DRAINAGE PLAN
STA. 145+00 TO 150+00

FARRINGTON HIGHWAY INTERSECTION IMPROVEMENTS
AT NANAKULI AVENUE AND HALEAKALA AVENUE
Federal-Aid Project No. STP-093-1(22)

CONTRACT CHANGE ORDER NO. 27
Attachment 1

DRAINAGE PLAN
STA. 182+00 TO 185+00

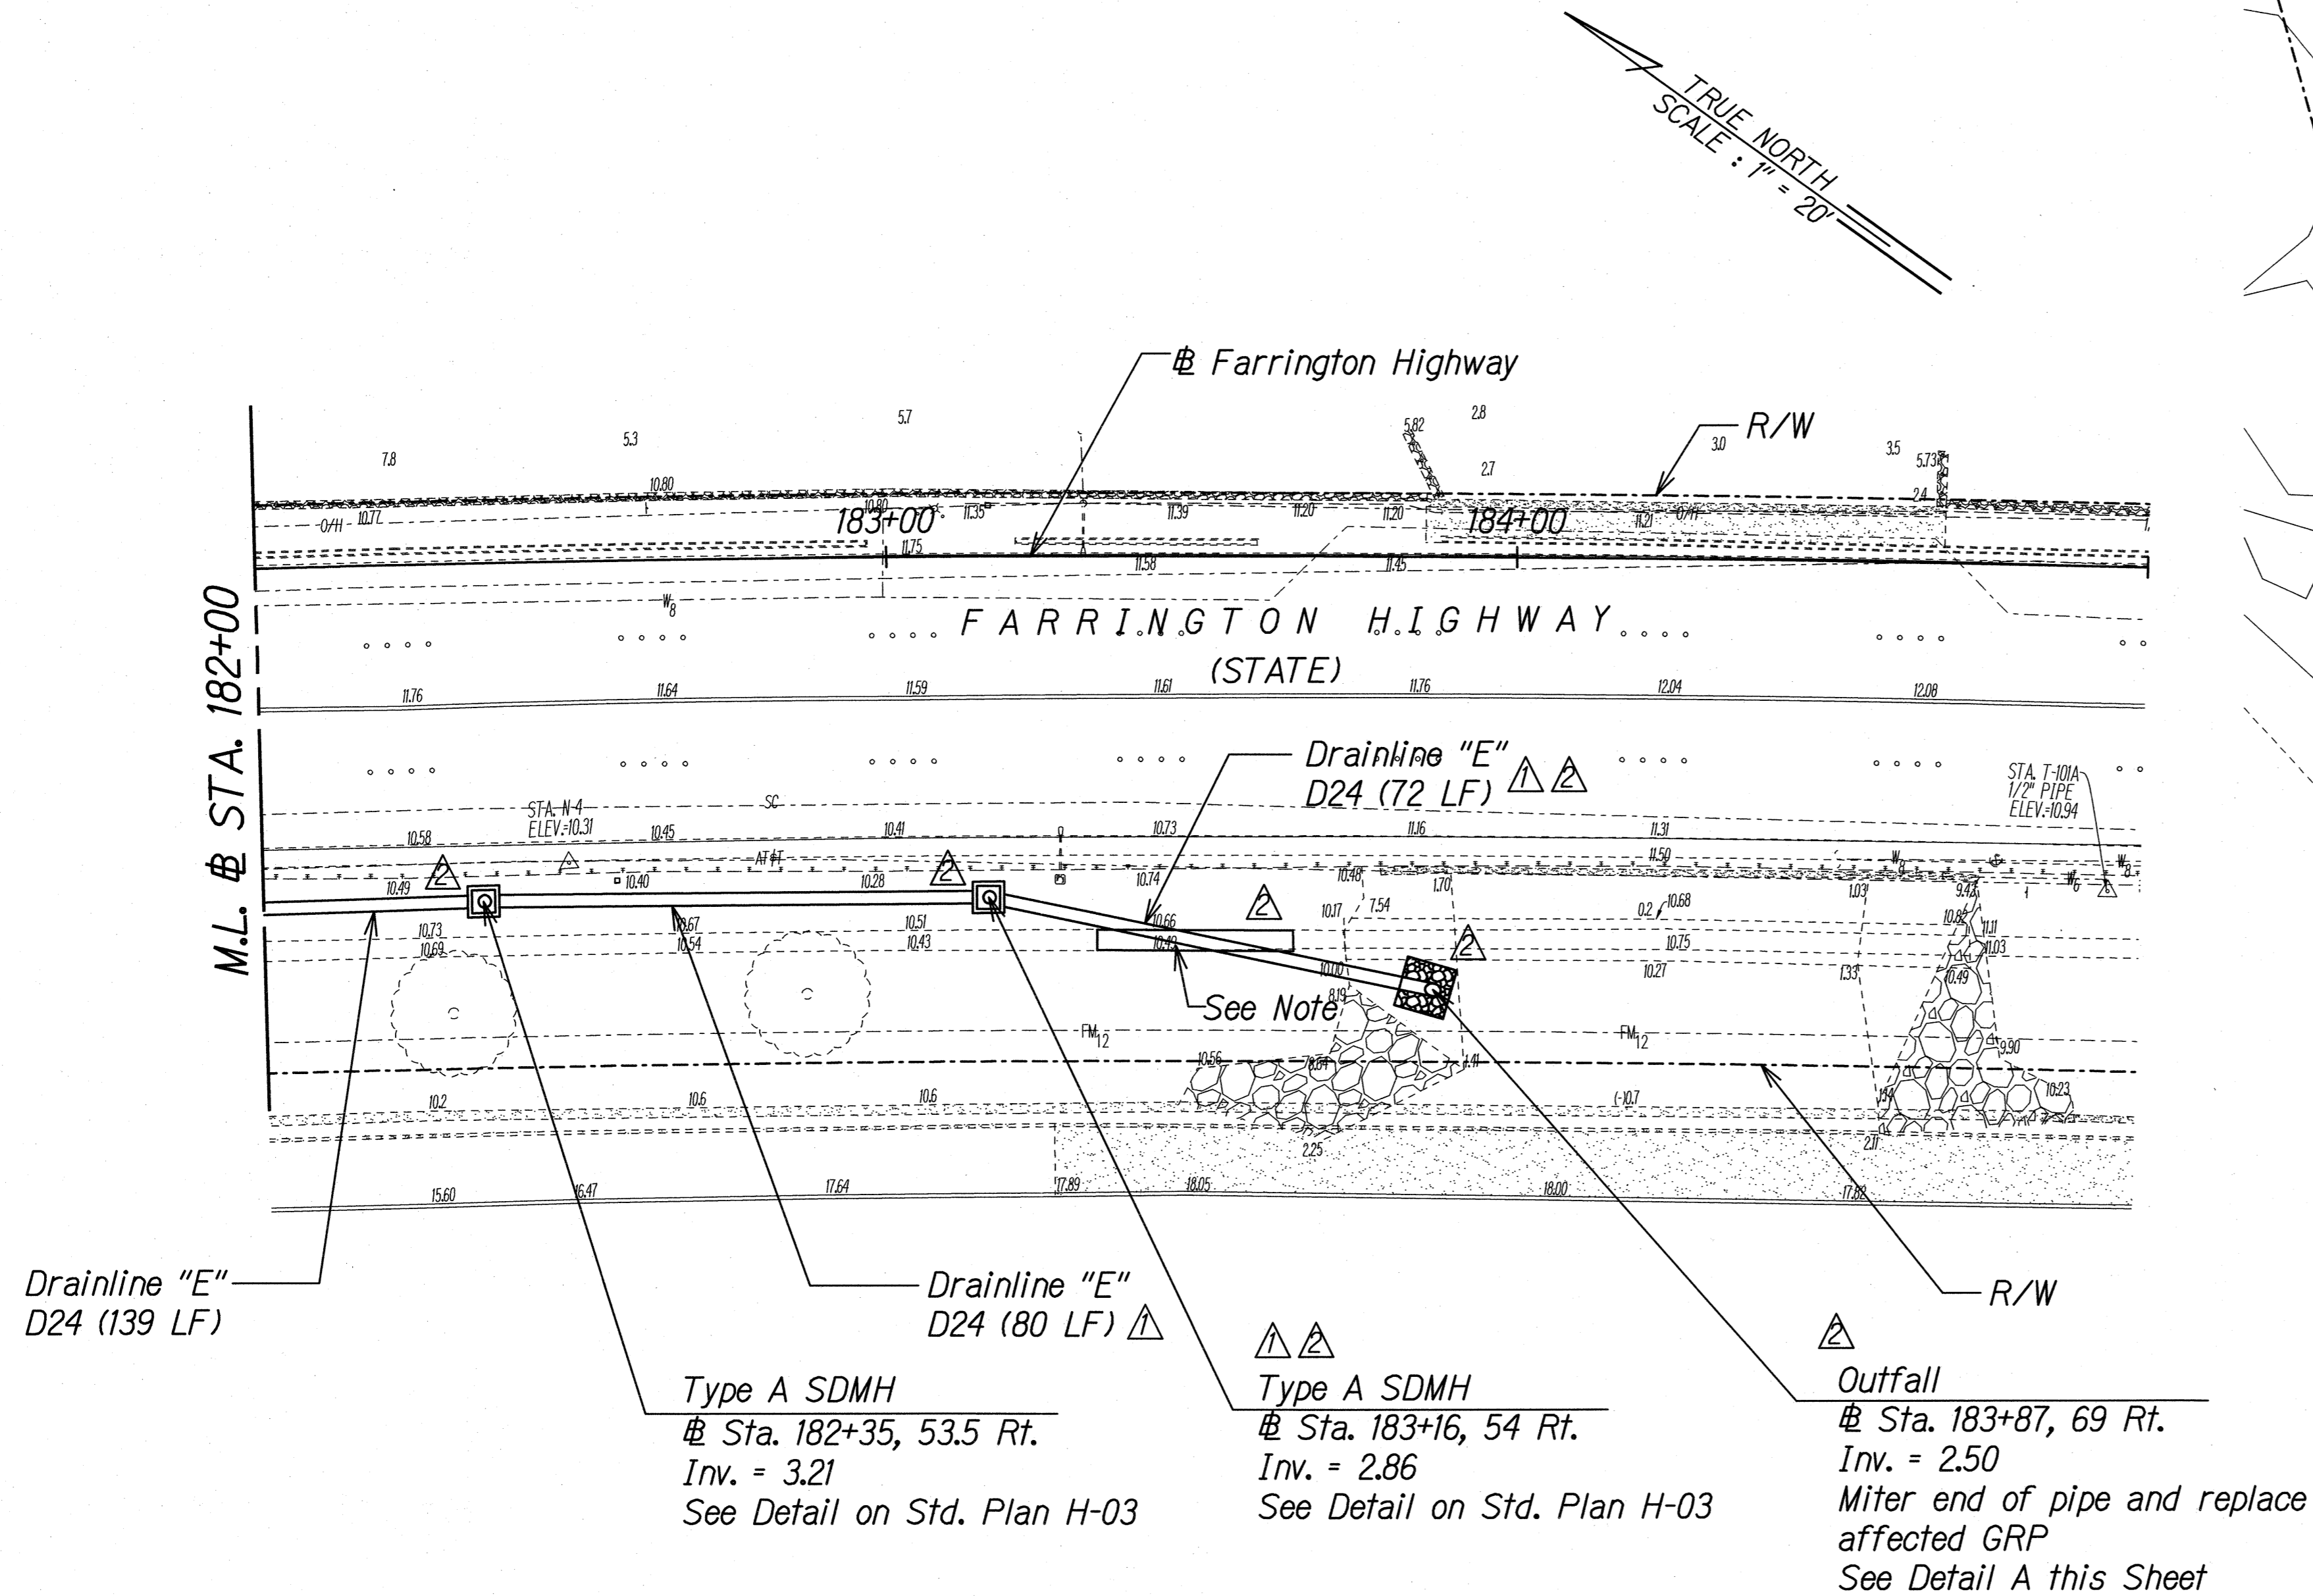
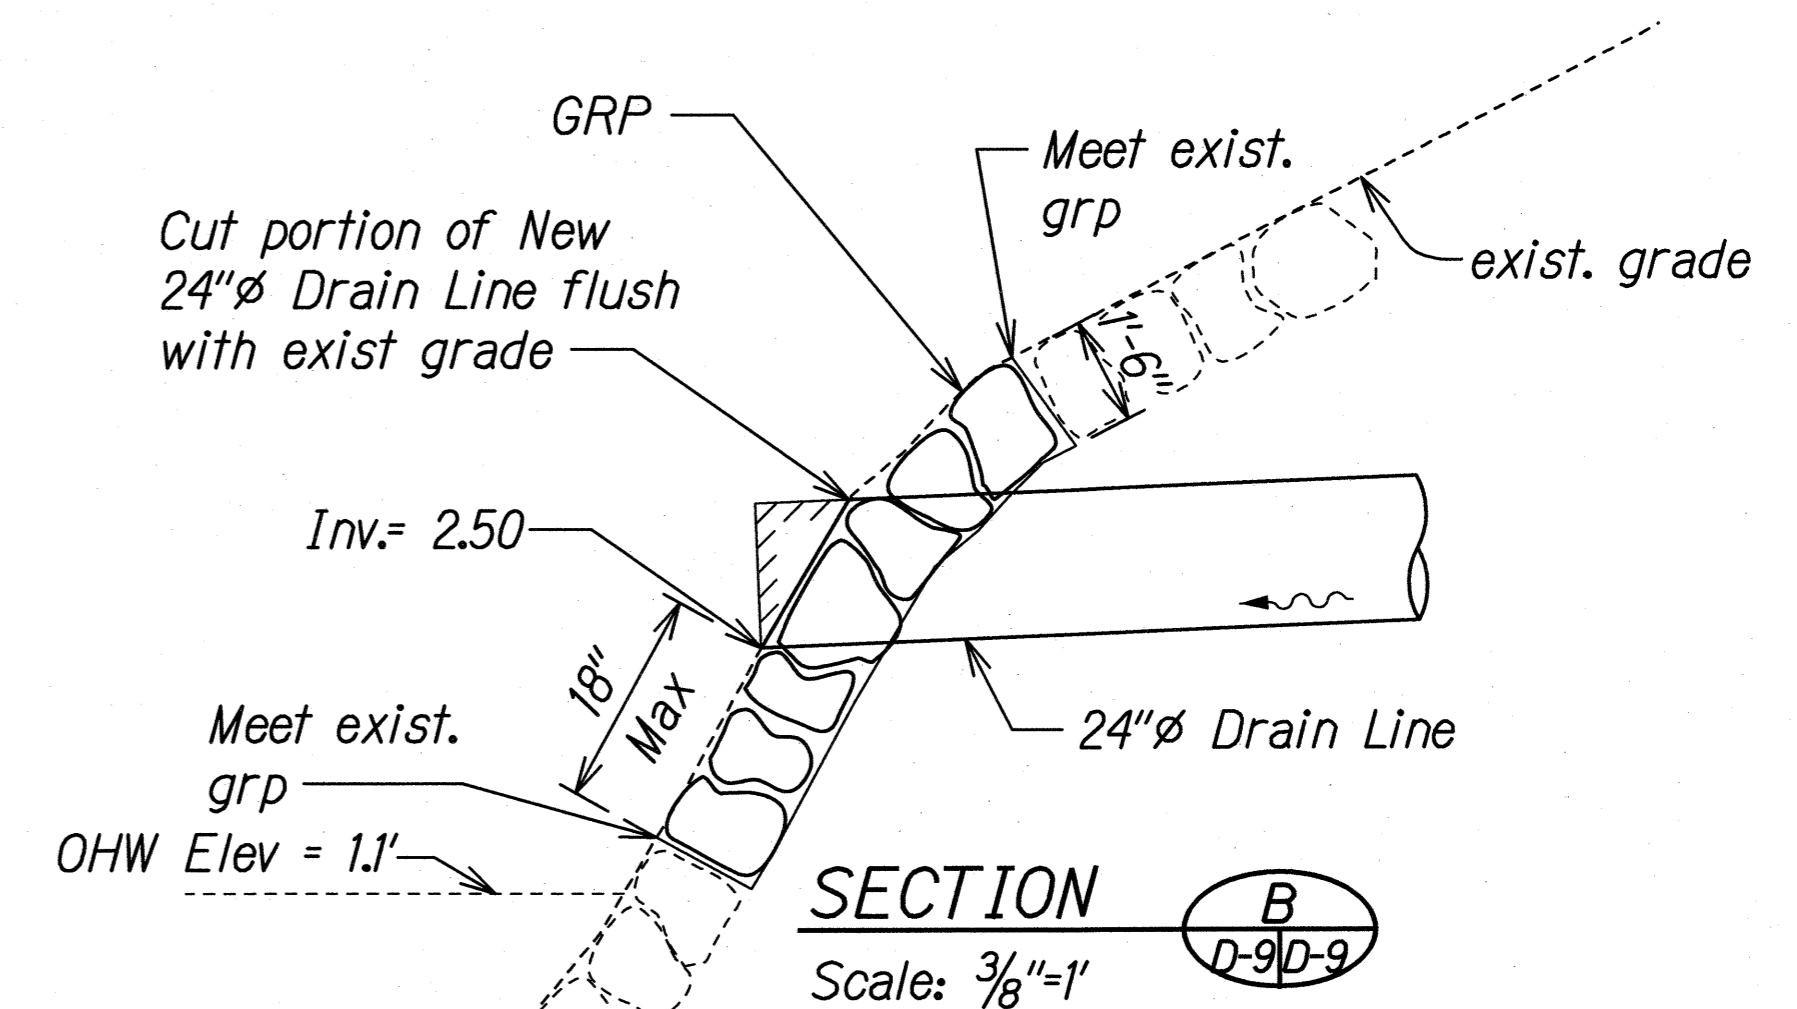
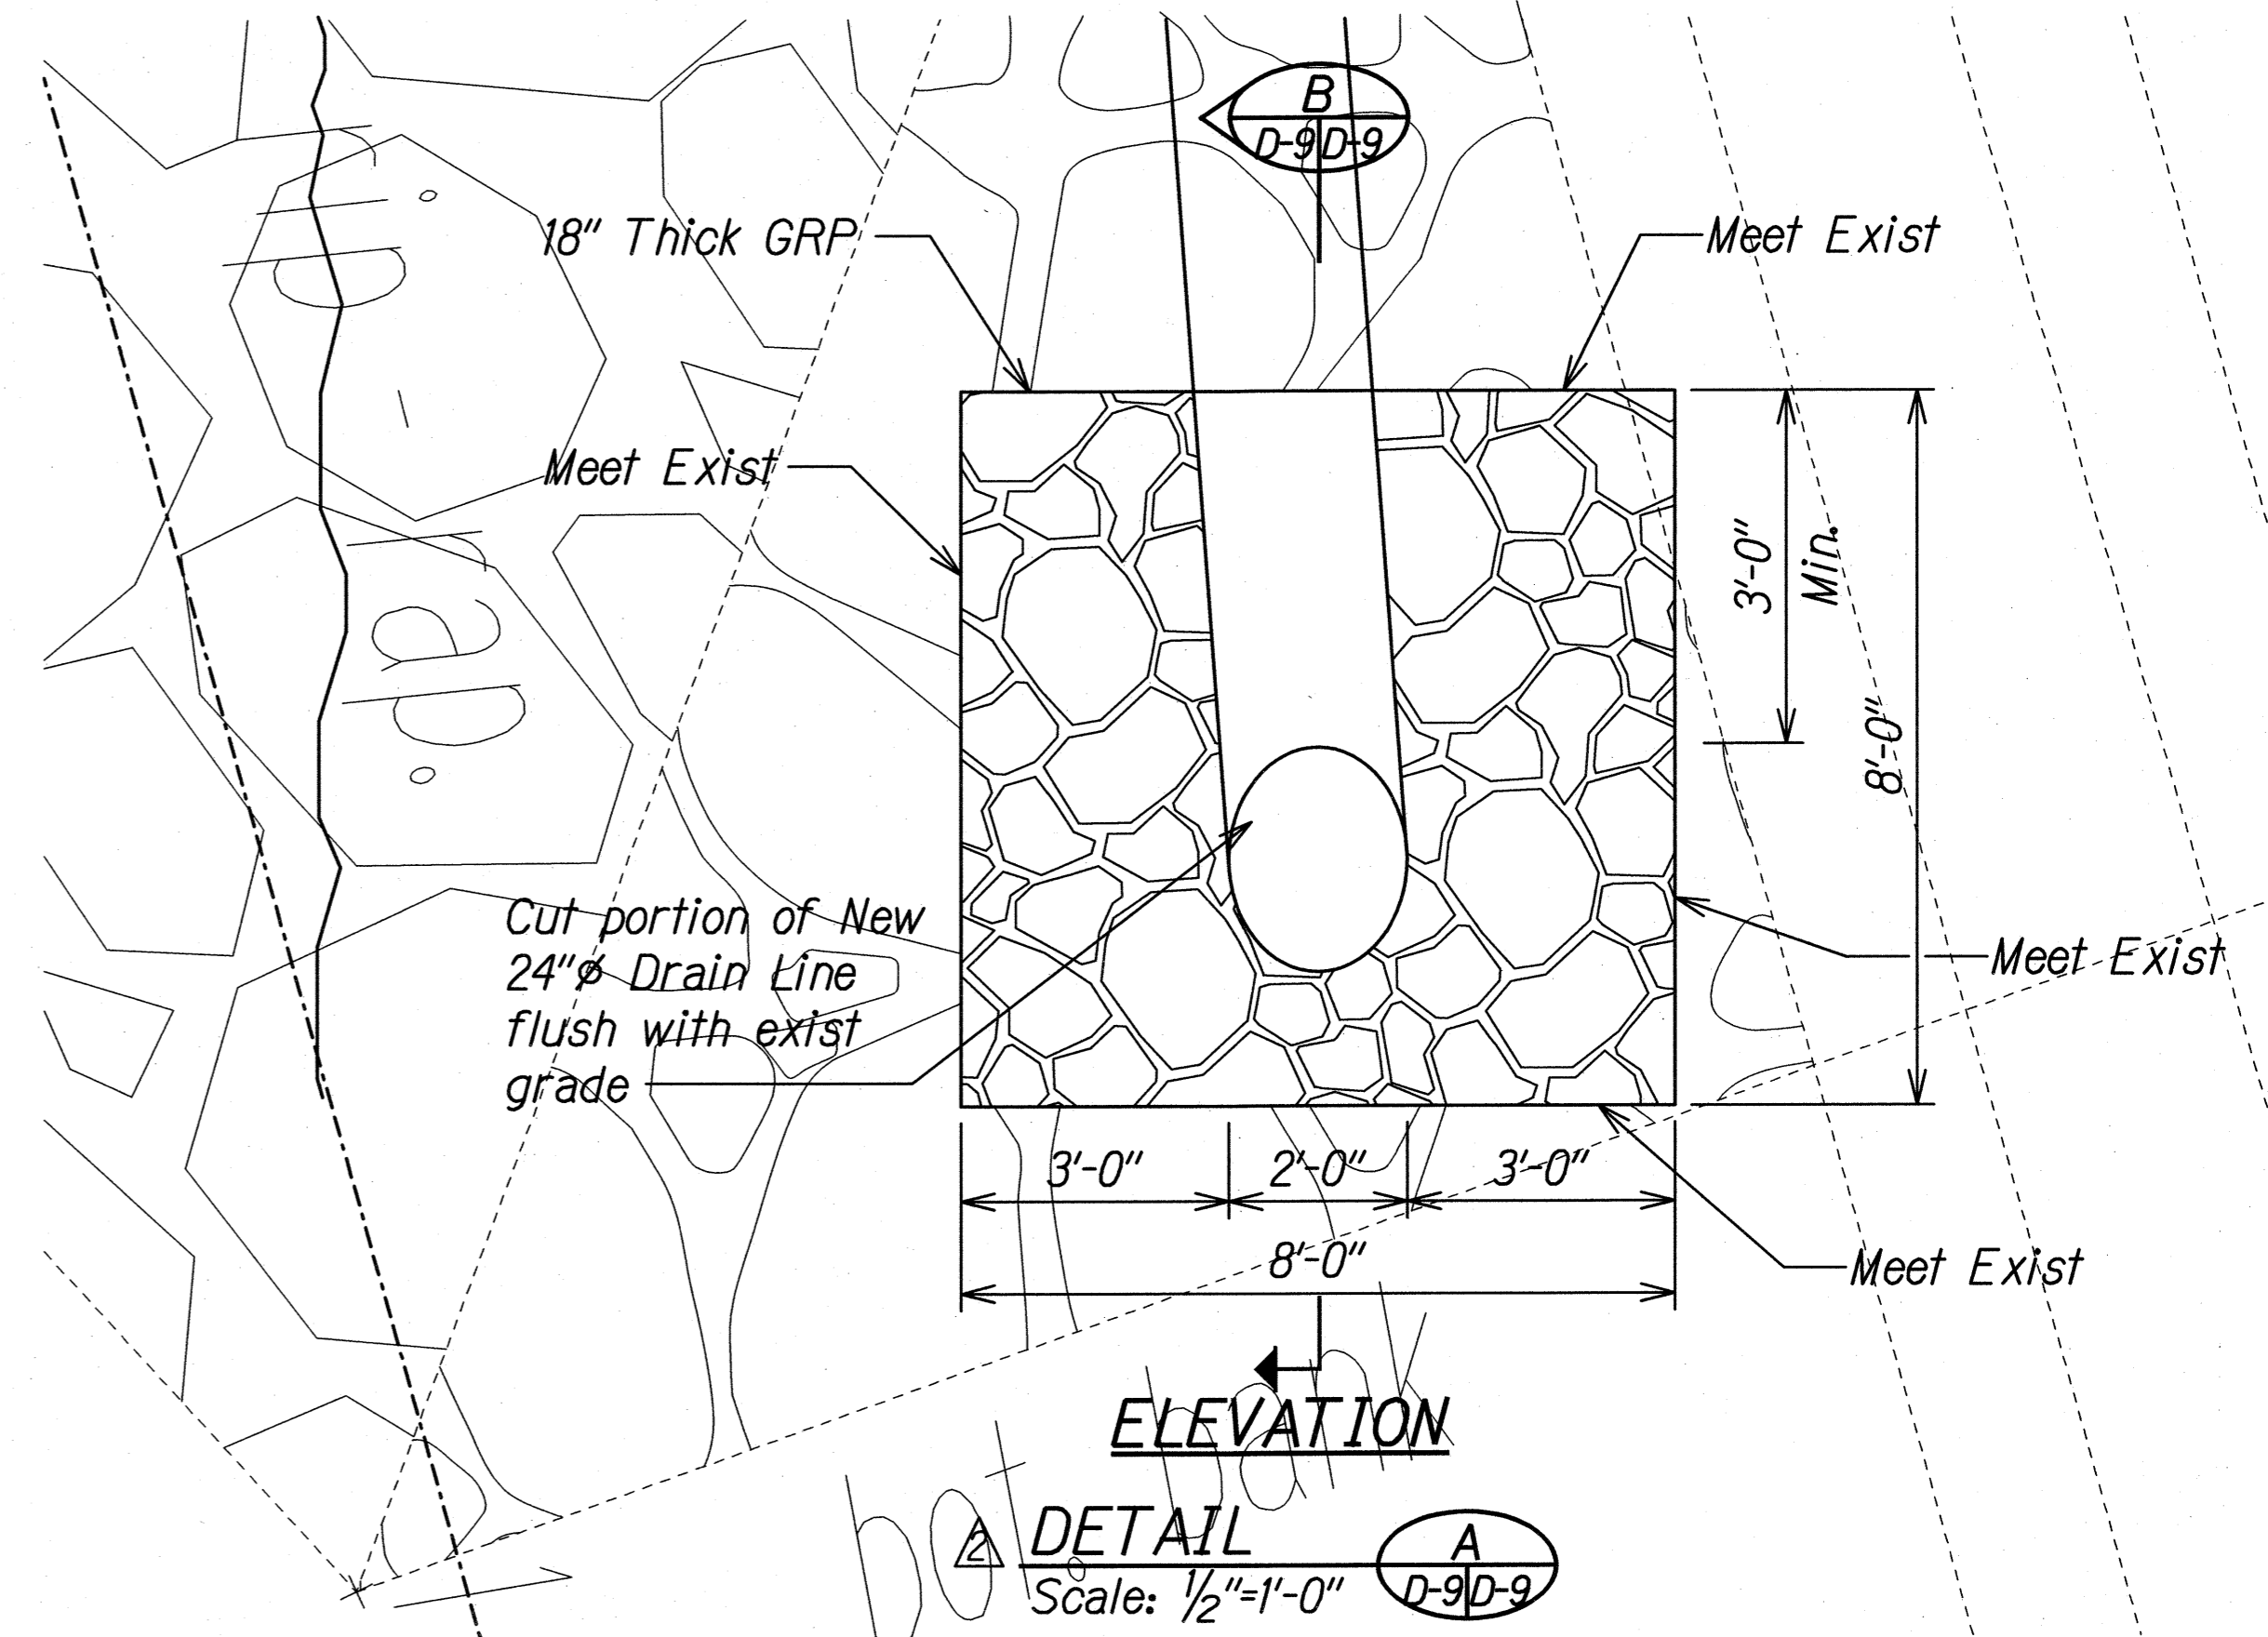
11/17/17	Revised Drainline "E"
4/23/15	Revised Drainline "E"
DATE	REVISION

- NOTE:**
- 1) Restore rail tracks upon completion of drainline.
 - 2) All construction work shall occur above the Ordinary High Water (OHW) Mark elevation = 1.1'
